TITLE	PARTIAL MEZZANINE/LOW ROOF FRAMING PLAN - AREA B (SEQ-1)		
MADE BY	DATE	CONTRACTOR	JOB No.
PDS	11/30/2020		20028
CHKD BY	DATE	ARCHITECT	ENGINEER
JSY	11/30/2020		
			SHEET NO.
			1E1
			REV.
			A

**PARTIAL MEZZANINE/LOW ROOF FRAMING PLAN @ AREA-B (SEQ-1)**  
 (REF: S2.2 & 1/A1.3)  
 [TOP OF STEEL ELEVATION 114'-0 1/2" U.N.O.]

ISOMETRIC VIEW

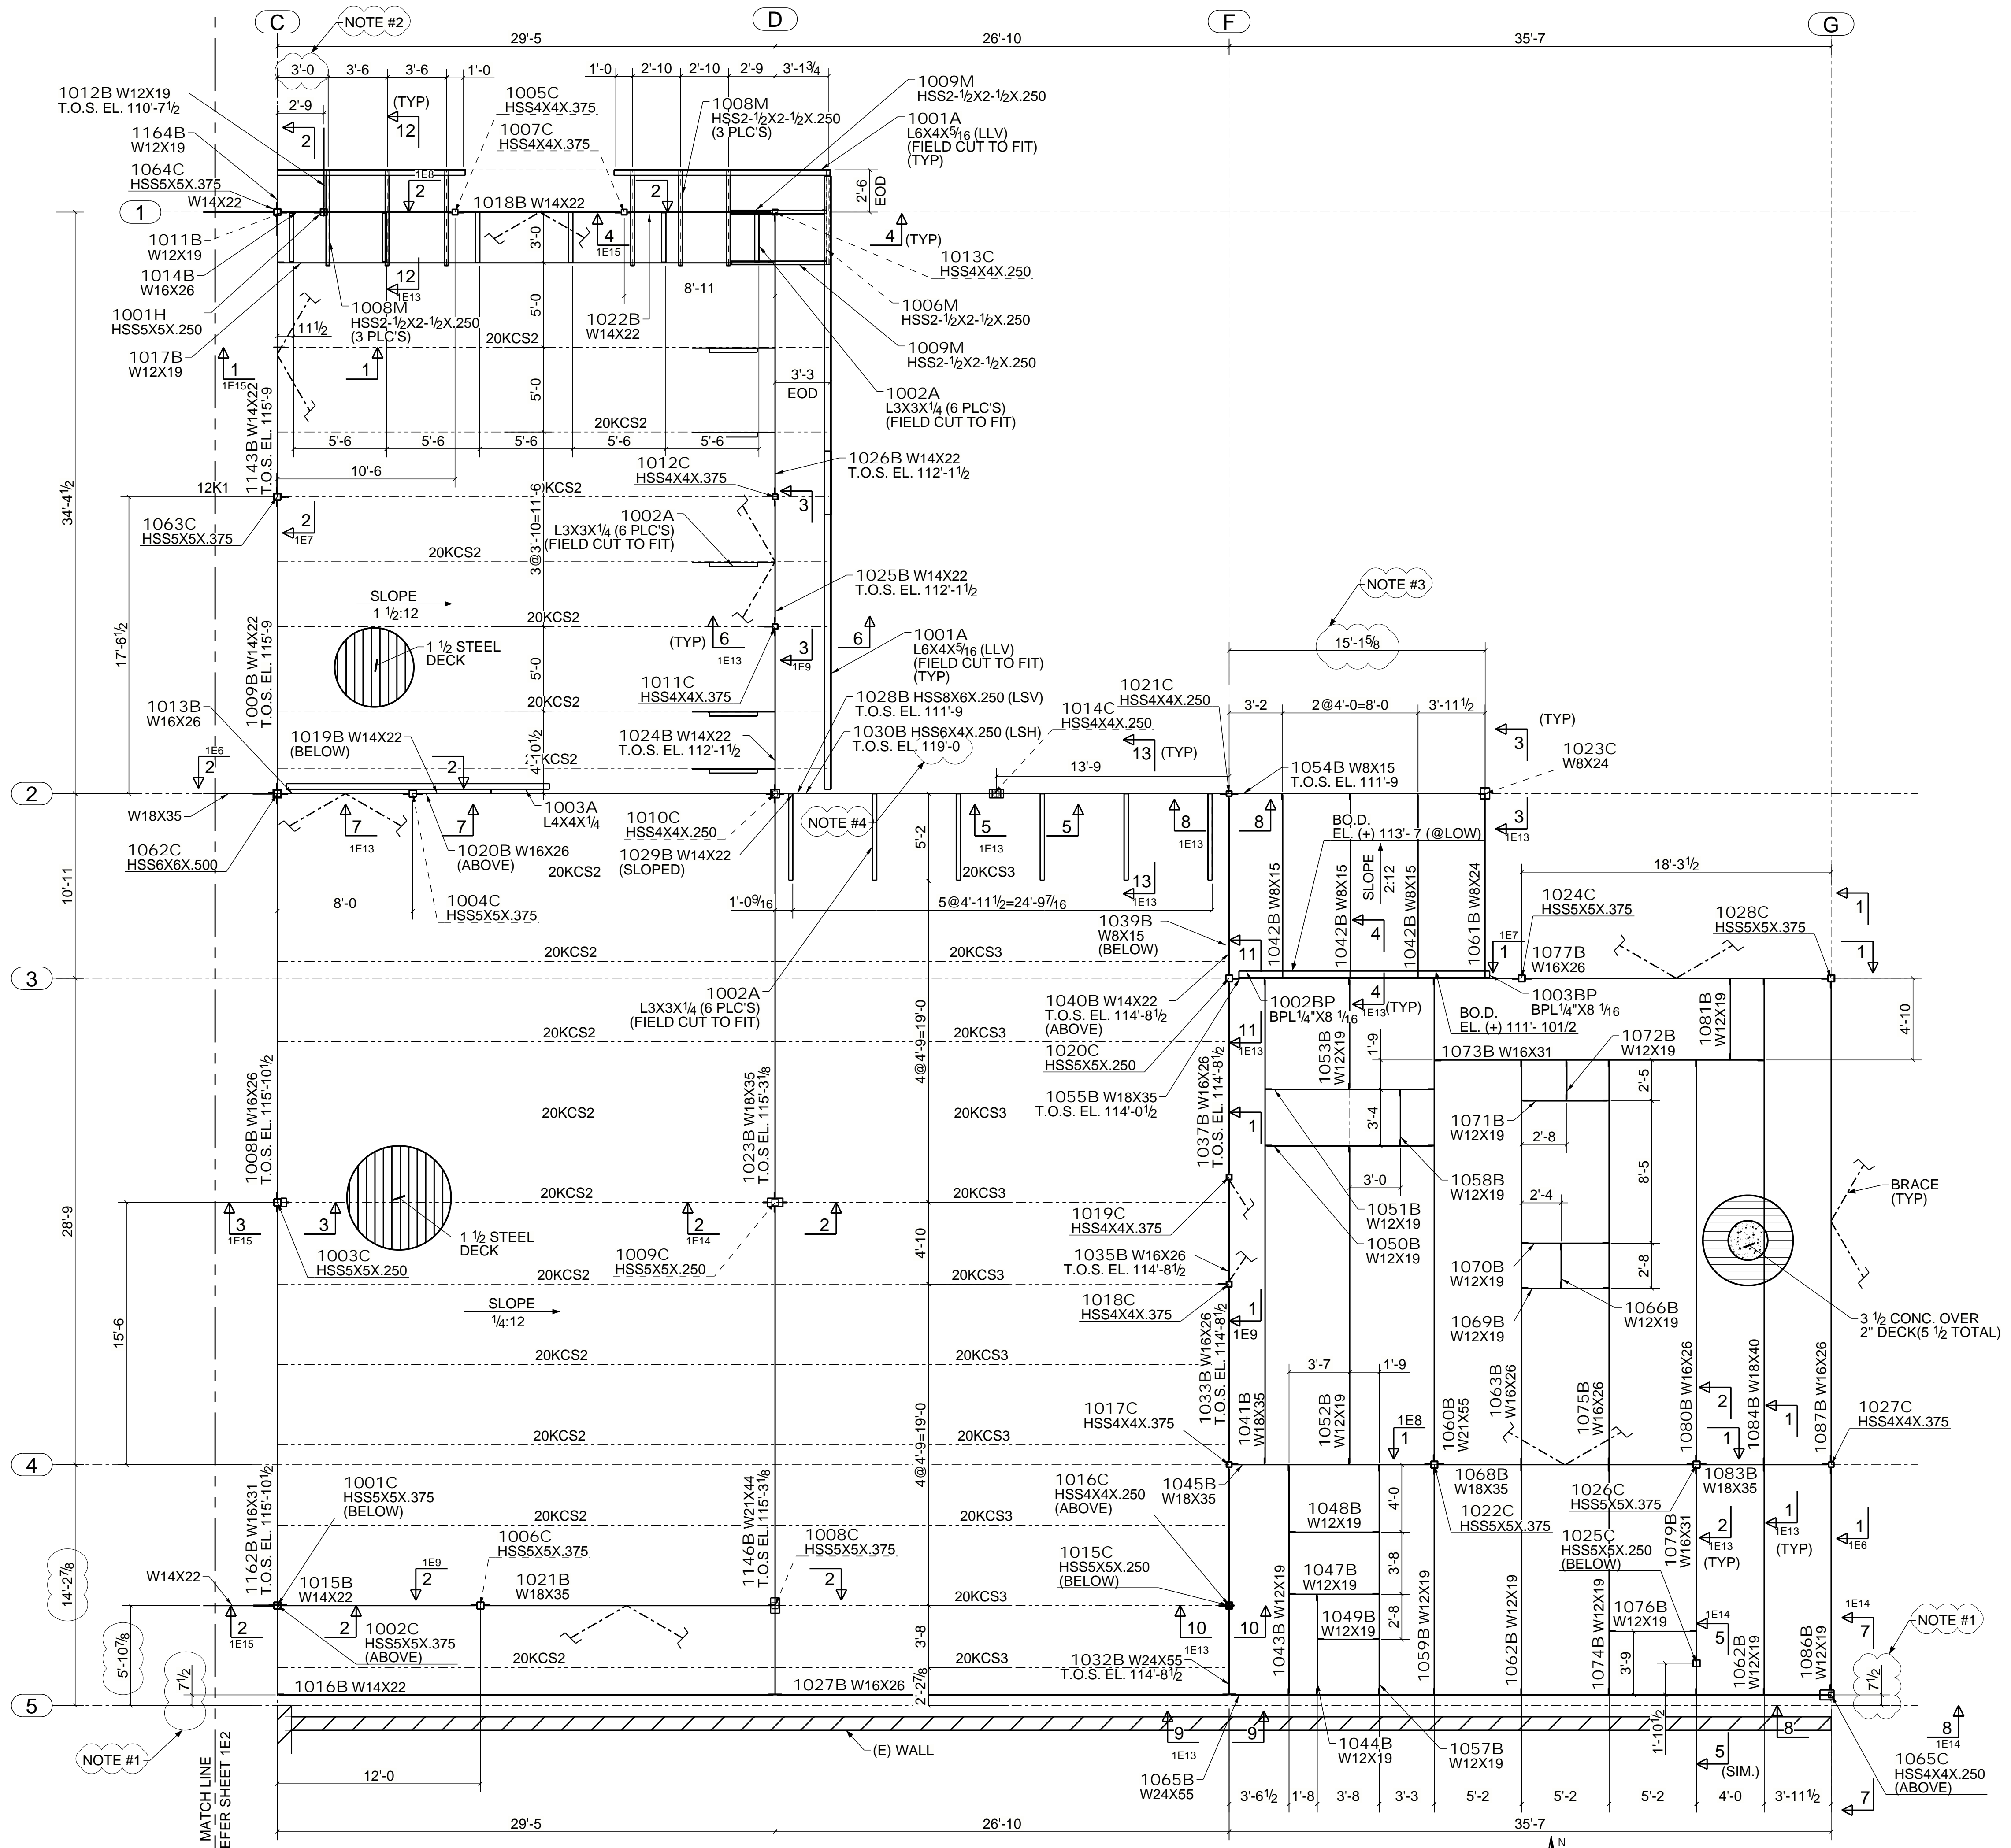
NOTE #1:- PLEASE VERIFY/PROVIDE BEAM FIXING DIMENSION.

NOTE #2:- PLEASE VERIFY/LOOKER HSS FIXING DIMENSION.

NOTE #3:- THERE IS CONFLICT IN COLUMN LOCATING DIMENSION. STRUCTURE PLAN S1.2 SHOWS 15'-1 1/2" FROM GRID LINE-F, BUT PLAN S2.2 SHOWS 15'-2" FROM GRID LINE F. CURRENTLY WE HAVE FOLLOWED 15'-1 1/2" AS PER PLAN S1.2. PLEASE REVIEW/CONFIRM.

NOTE #4:- PLEASE VERIFY/PROVIDE HIGH GIRT BEAM HSS 6x4 ELEVATION.

PARTIAL MEZZANINE/LOW ROOF FRAMING PLAN @ AREA-B (SEQ-1)  
 (REF: S2.2 & 1/A1.3)

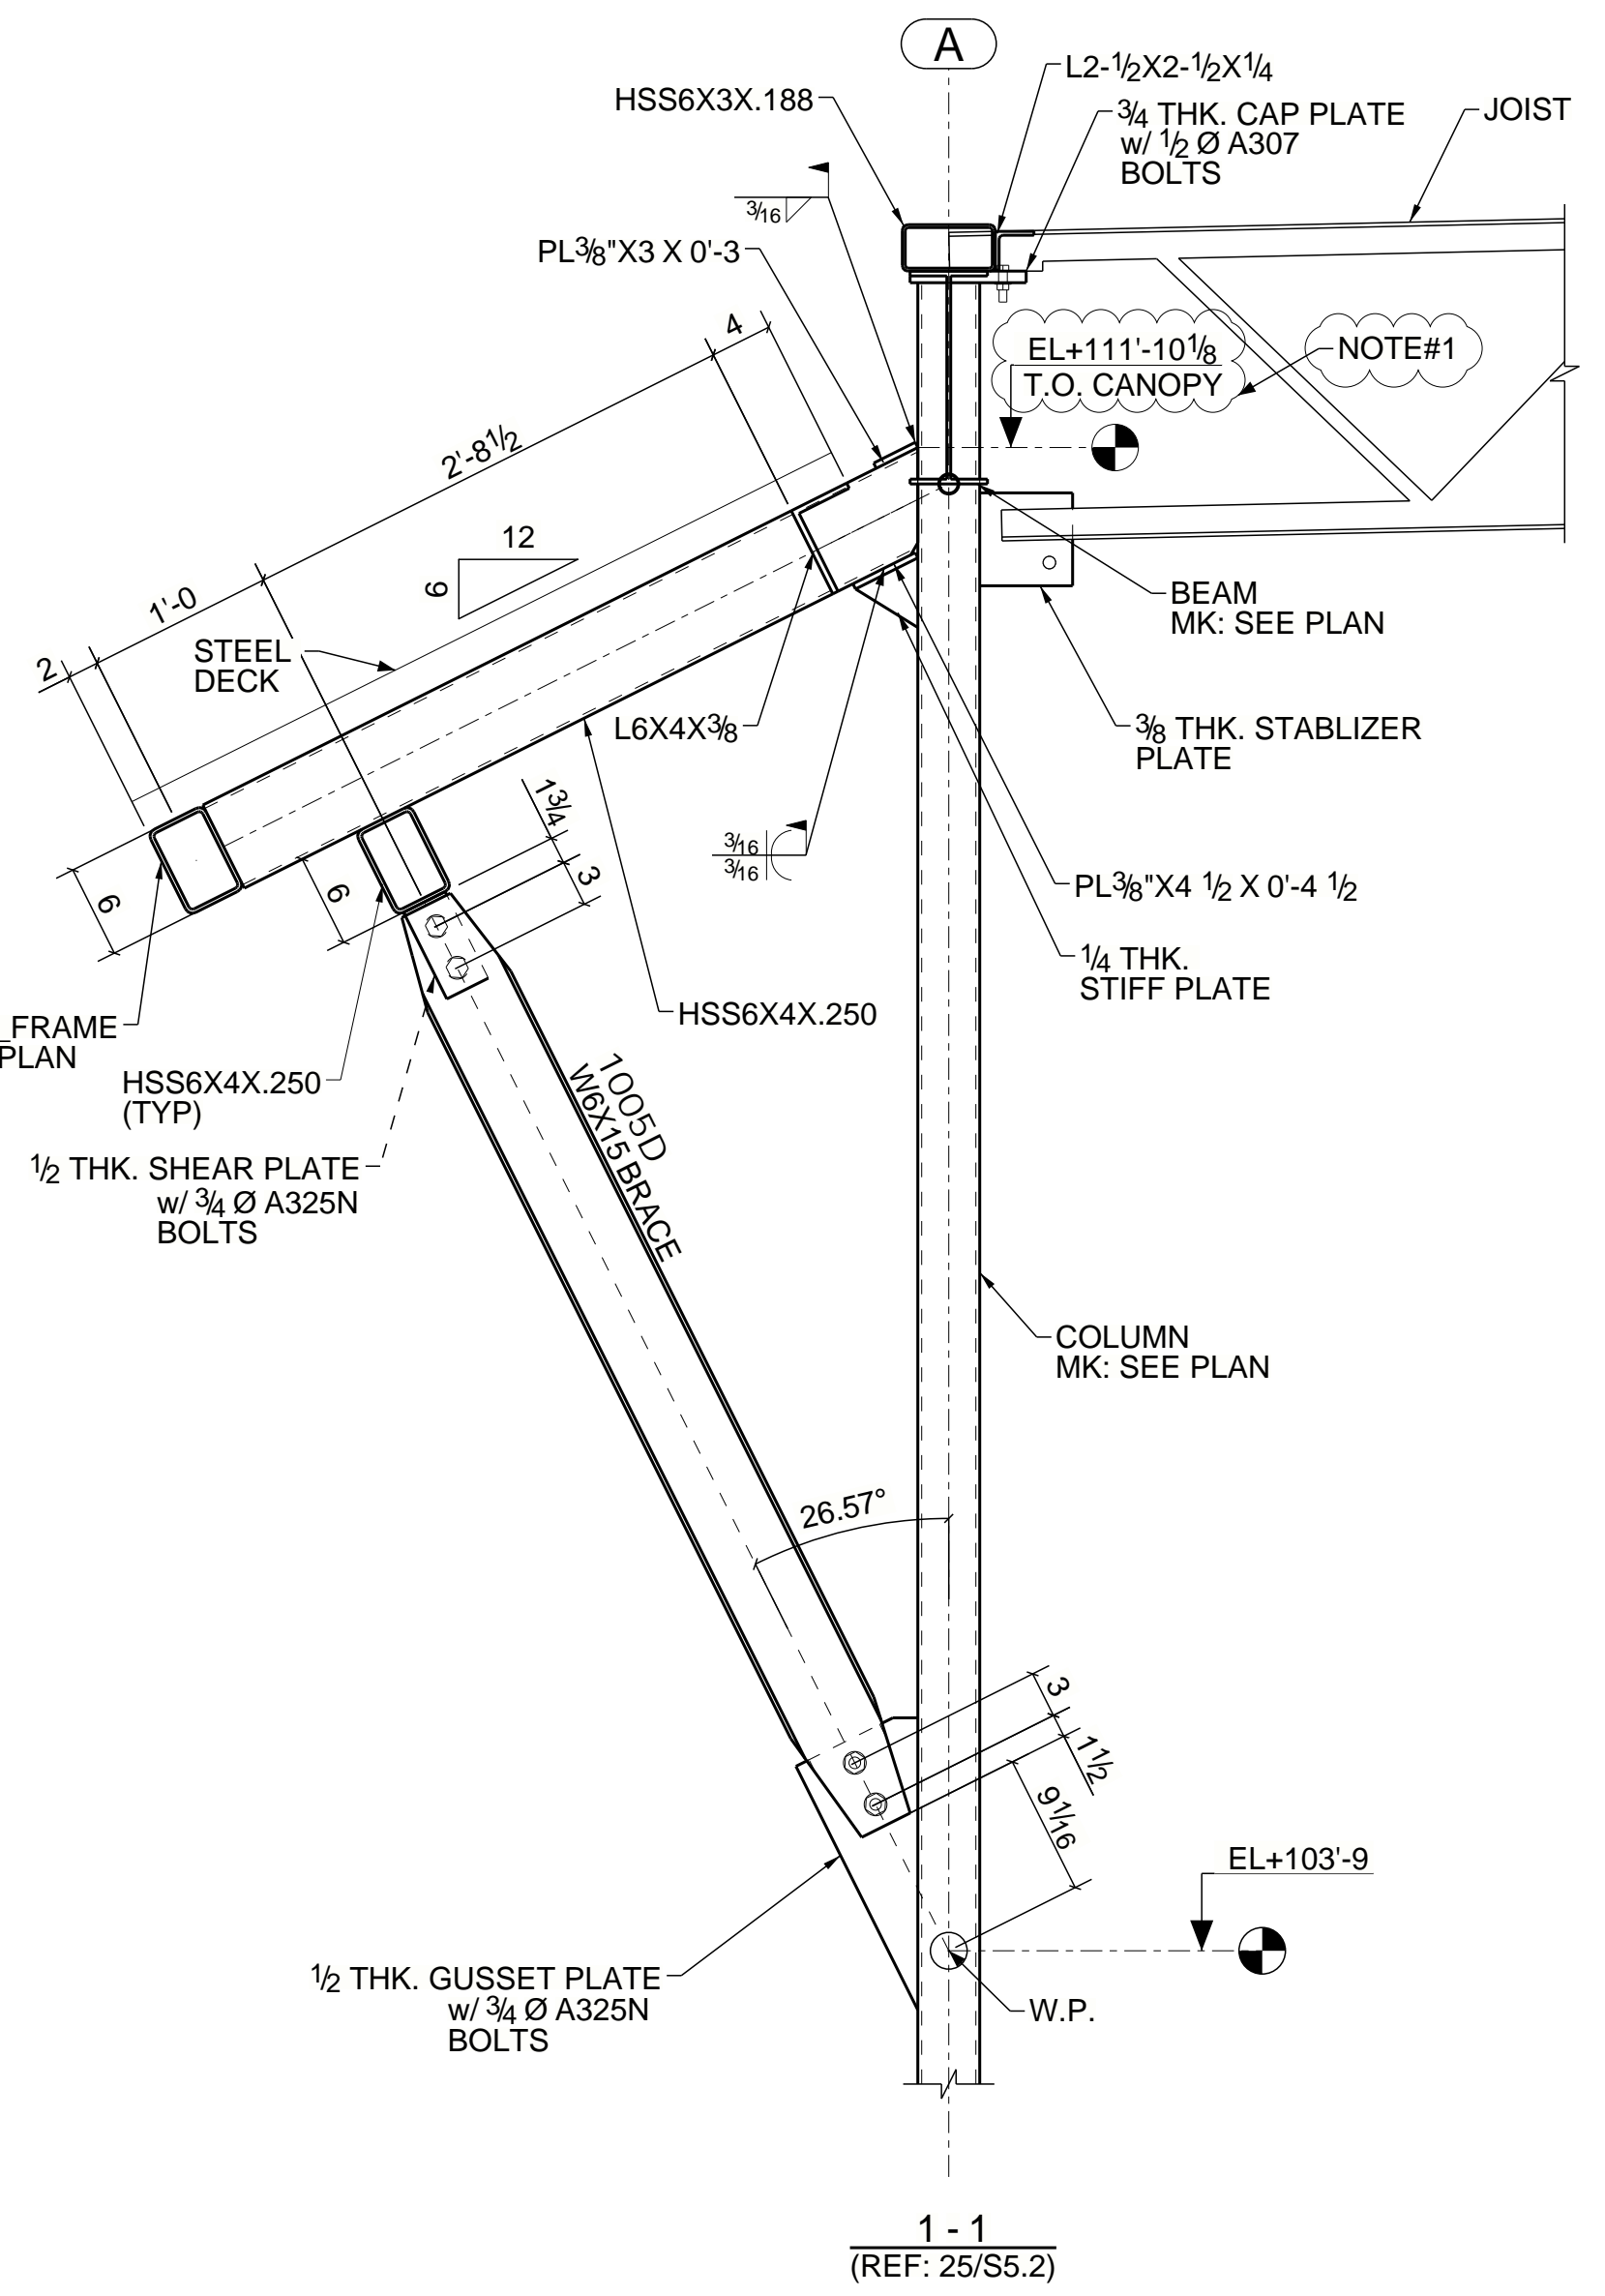
NOTE#1:- WE HAVE CONSIDERED TOP OF STEEL ELEVATION OF THIS BEAM 113'-3 1/4 INSTEAD OF 113'-0 3/4 AS SHOWN IN STRUCTURE PLAN S2.2, BECAUSE THIS BEAM IS DECK BEARING NOT JOIST BEARING. PLEASE VERIFY/SUGGEST.
